Access Compliance Report

Public Rights-of-Way

Intersection ID: 7457	Main Street: CANTERWOOD_DR	Cross Street: ELGYWOOD_LN	Location: NE
ADA ID: 74BEE18674FA	Ramp Type: Perp	Initial Pass/Fail: Fail	Overall Compliance: No
		Severity Score: 12.5

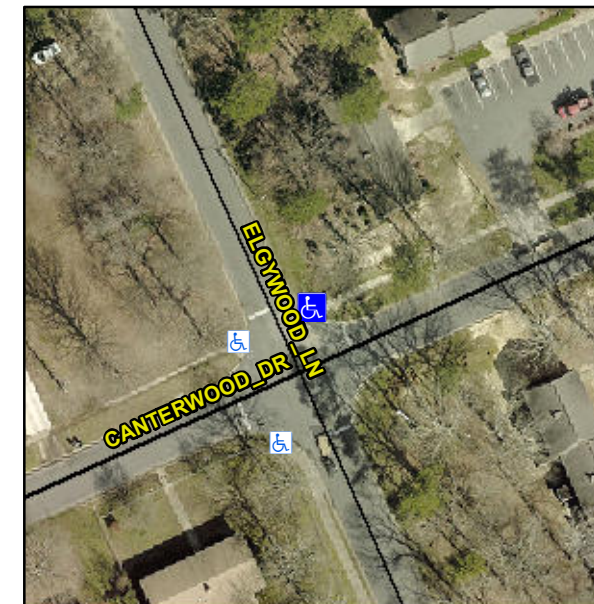
Not Found, R304.2.2

Compliance	Description	Data	Compliance	Description	Data
N/A	Ramp Length (in)	25.0	No	Ramp Slope (%)	10.7
Yes	Ramp Width (in)	48.0	Yes	Ramp XSlope (%)	0.7
N/A	Flare Type LT	N/A	N/A	Flare Type RT	N/A
N/A	Flare Slope LT (%)	N/A	N/A	Flare Slope RT (%)	N/A
N/A	Flare Traversable LT?	N/A	N/A	Flare Traversable RT?	N/A
N/A	Landing Length (in)	N/A	N/A	DWS Provided?	N/A
N/A	Landing Width (in)	N/A	N/A	DWS Contrast?	N/A
N/A	Landing Slope (%)	N/A	N/A	DWS Length (in)	N/A
N/A	Landing X Slope (%)	N/A	N/A	DWS Full Width?	N/A
N/A	Landing Curb? (Y/N)	N/A	N/A	DWS Offset (in)	N/A
N/A	Shared Landing?	N/A			
N/A	Gutter Ponding?	Yes	N/A	Gutter Slope (%)	N/A
N/A	Gutter Lip Ht (in)	N/A	N/A	Gutter X Slope (%)	N/A
N/A	Painted X Walk1?	No	N/A	Painted X Walk2?	N/A
	X Walk 1 Direction	To W		X Walk 2 Direction	N/A
N/A	X Walk 1 Width (in)	N/A	N/A	X Walk 2 Width (in)	N/A
	X Walk 1 Slope (%)	3.5		X Walk 2 Slope (%)	N/A
	X Walk 1 X Slope (%)	0.4		X Walk 2 X Slope (%)	N/A

Remove & Replace Entire Ramp.
